APPLICATION NO.	FILING DATE	FIRST NAMED INVENTOR	ATTORNEY DOCKET NO.	CONFIRMATION NO.
10/695,144	10/28/2003	Peter Van De Witte	NL 000326A	6435

CHOWDHURY, TARIFUR RASHID

Office Action Summary

FIG.1

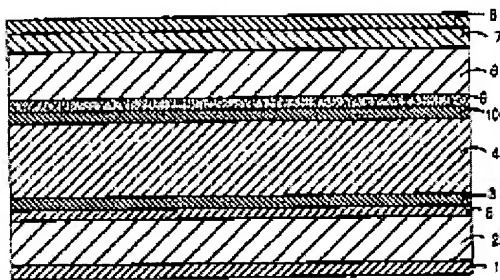
6. Kim discloses (col. 2, lines 64-67; col. 3, lines 1-8, 19-38) and shows in Fig. 1, a reflective active matrix liquid crystal display device comprising a liquid crystal layer (4) dispersed between an active (2) and a passive substrate (6) plate,

the active substrate plate (2) being present on the side opposite the viewing side and comprising a plurality of optically transparent pixel electrodes (3) and a plurality of active switching elements (not shown) for controlling the voltage supplied to the pixel electrodes,

the switching elements being spatially separated from, positioned subjacent, and electrically connected to the plurality of pixel electrodes (not shown) (col. 3, lines 31-38),

wherein the spaces separating the switching elements and the pixel electrodes is filled with an electrically insulating color selection layer (5) which selectively reflects light of particular wavelengths and renders the switching elements invisible to the light reflected.

Accordingly, claim 18 is anticipated.
